Application Number: 09/506,533
Filing Date: February 17, 2000
Appellants: DECRISTOFARO ET AL.

EXAMINER'S ANSWER

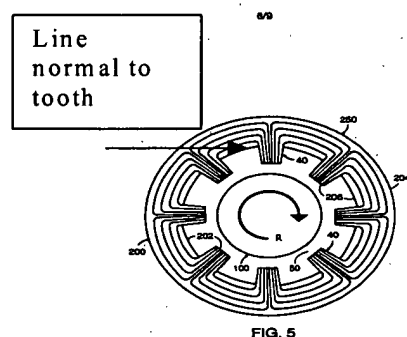
The Applicant's amended drawing 4a filed 10/31/2003 show two normal lines, one extending to the left of the page and one extending to the top of the page. The line normal to the teeth section 230 is not substantially perpendicular to the axis of rotation. (perpendicular = geometric objects are perpendicular if they intersect at an angle of 90 degrees, McGraw Hill Dictionary of Scientific and Technical Terms). The examiner has added an arrow to figure 5 to clearly demonstrate that a line normal to the top and

bottom surfaces of the tooth section does not intersect the axis of rotation (center of the circular stator), therefore it cannot be perpendicular to the axis of rotation.
